From: Andrew McRoyall
Sent: 07 September 2015 11:52
To: Planning
Subject: FW: Cloughton Fields Variation of Condition 2015/0570/FL
Attachments: 17 rev E Stable.pdf

Further to the application NYM/2015/0570/FL we submit a revised drawing 1005263/17 rev E (to replace 1005263/17 rev D), which contains some minor amendments to the stable block.

PROJECT TITLE
PROPOSED NEW FARM STEADING
CLOUGHTON FIELDS FARM, SCARBOROUGH

DRAWING TITLE
PROPOSED PLANS AND ELEVATIONS
STABLES

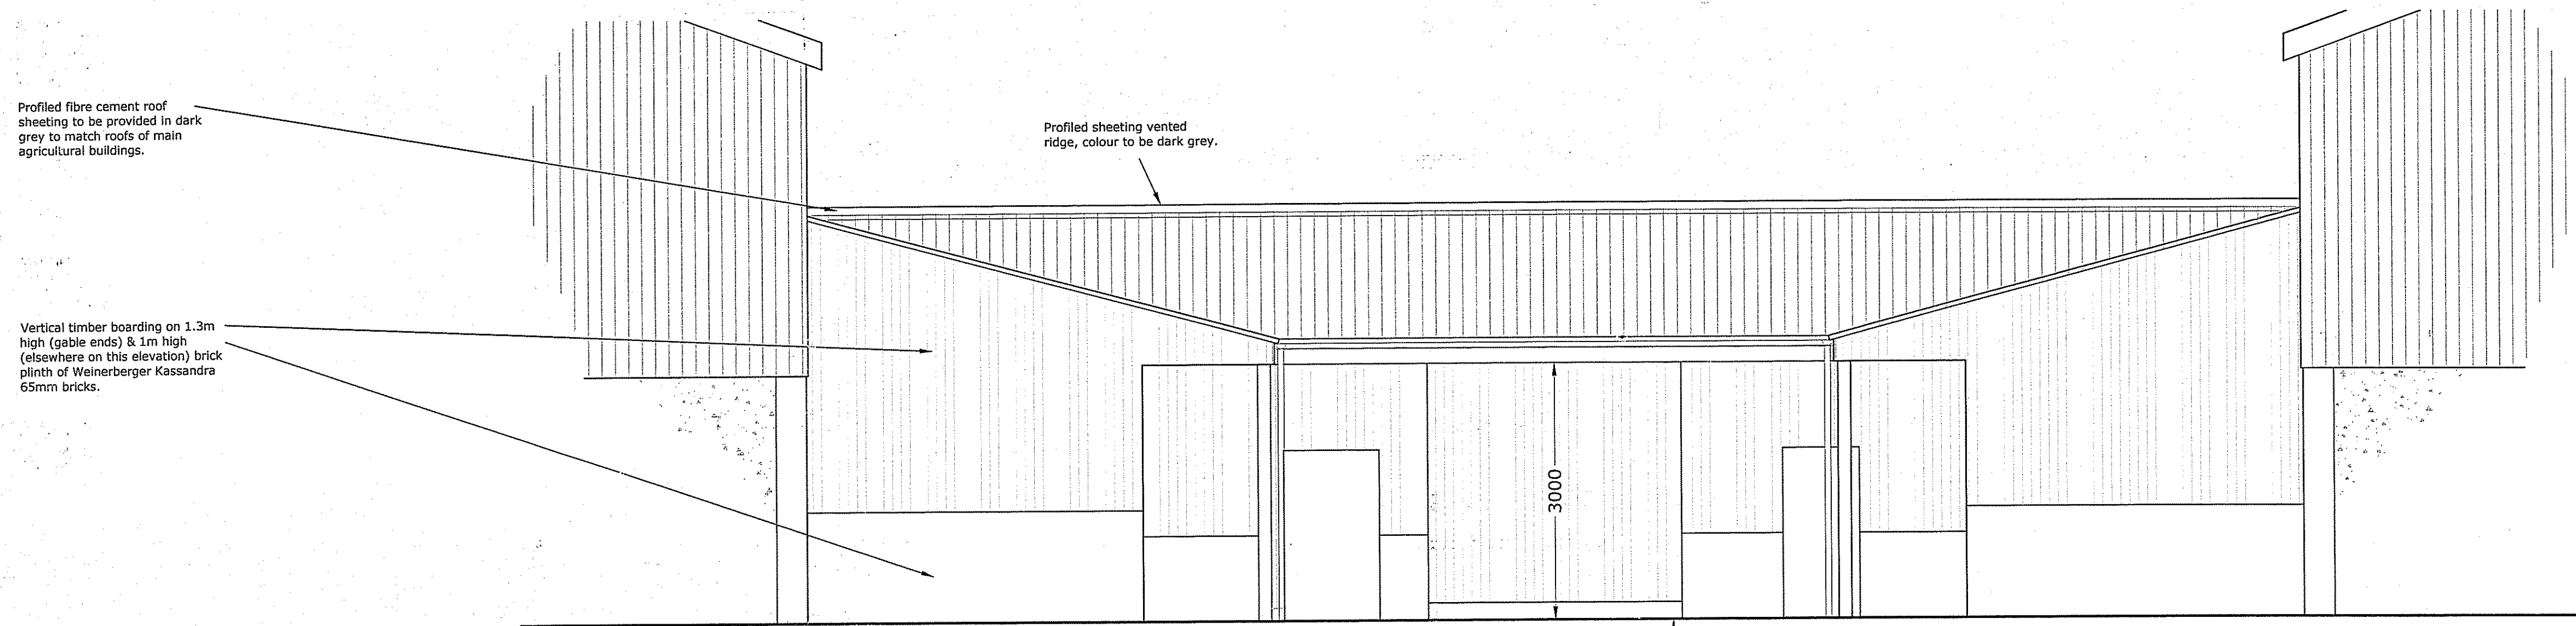
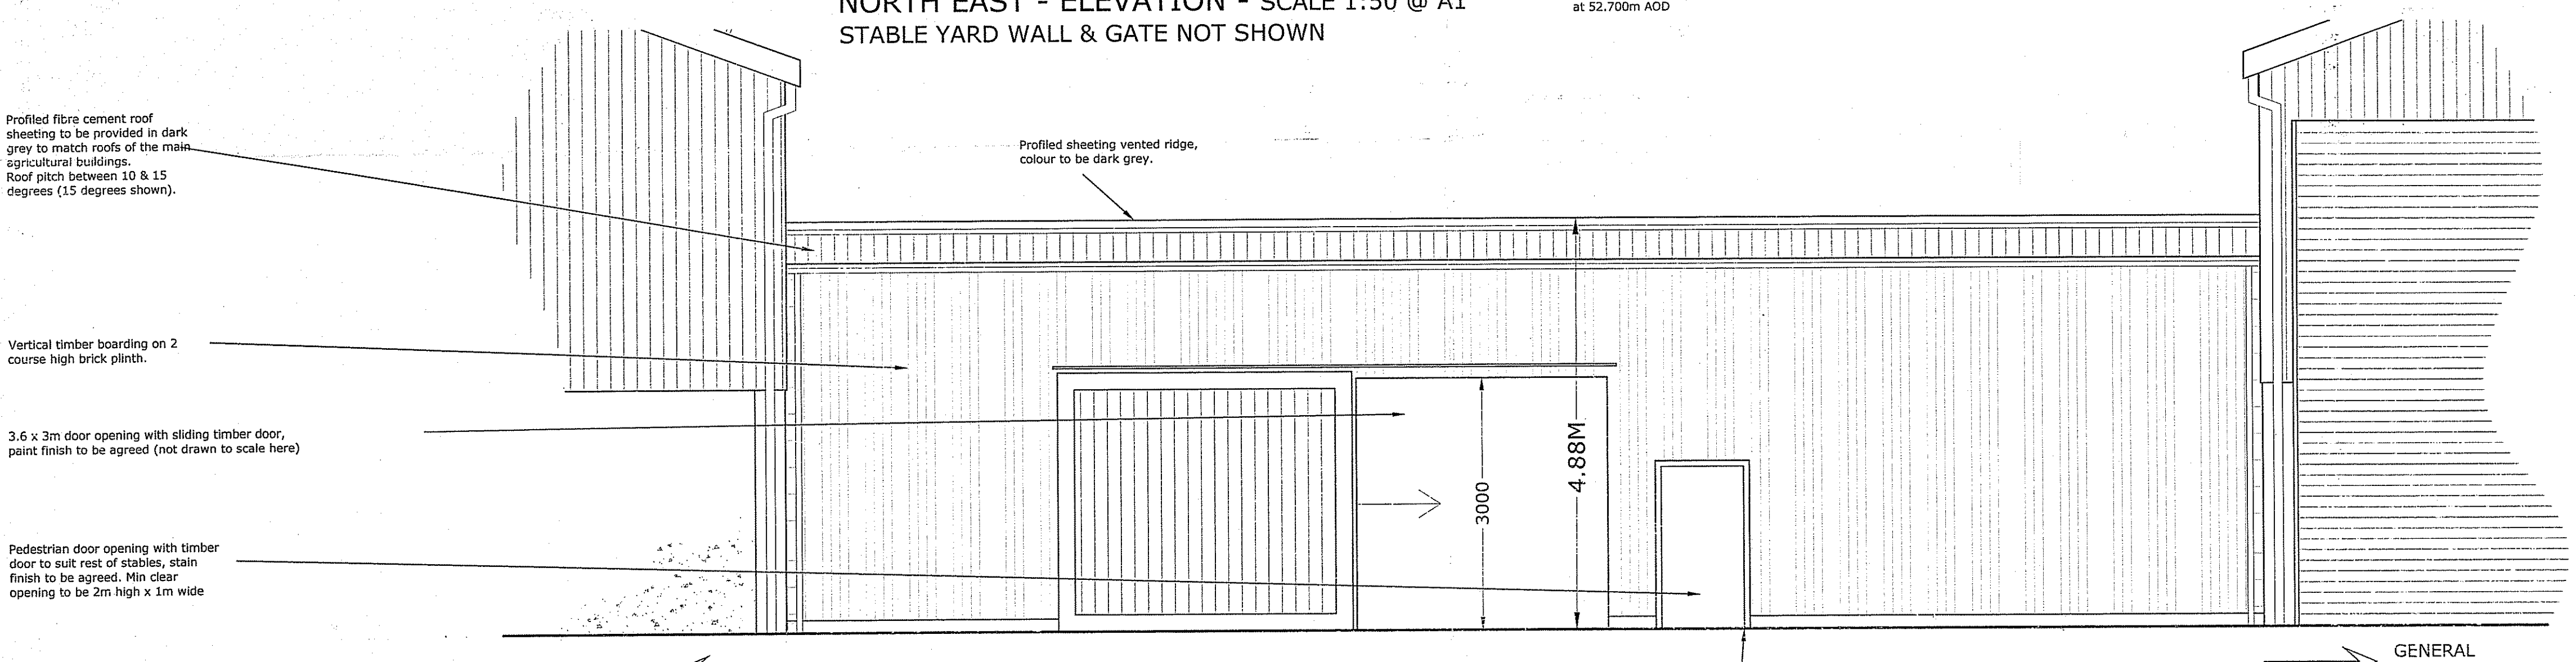
The brickwork plinth on the eastern sides is raised to 1.3m / 1m and extended as a wall with gate to enclose the stable yard. The cladding is now shown as vertical, rather than horizontal and the ventilation grilles are omitted. The overall size and height remain the same.

REV	NOTE / DRAWN BY	DATE
A	Measurements shown, status updated to planning	25.03.13
B	Status revised to tender issue - RAS	25.06.13
C	Re-tender amendments	13.02.15
D	Roofing to match adjoining buildings. Yard level shown. (AMCR)	07.08.15
E	Brick plinth heightened. Timber cladding becomes vertical. Vents omitted. Yard wall & gate added. (AMCR)	04.09.15
